Service Bulletin

Bulletin No.: 18-NA-322

Subject: Drone Type Noise Heard While Air Conditioning (A/C) is On

Brand:	Model:	Model Year:		VIN:		Engine:	Transmission:
		from	to	from	to		
Chevrolet	Trax	2018	2019			1.4L (RPO LUV)

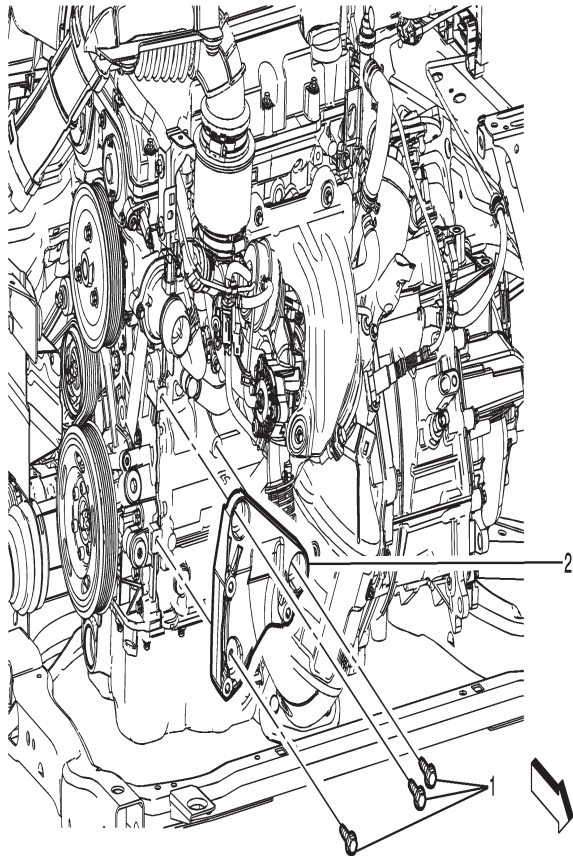
Involved Region or Country	North America, South America
Condition	Some customers may comment that a drone type noise can be heard when the A/C is on.
Cause	This condition may be caused by the A/C compressor mounting bracket bolts bottoming out in the engine block.
Correction	 <p style="text-align: right;">2790949</p> <p>If the droning noise has been validated to be caused during A/C compressor operation, replace the bracket bolts (1).</p>

Refer to *Air Conditioning Compressor Bracket Replacement* in SI.

Causal Part	Description	Part Number	Qty
N/A	BOLT, HFH, M8X1.25X30.7, 26 THD, 18 OD, 8.8, GMW3359, M-PT	11588724	3
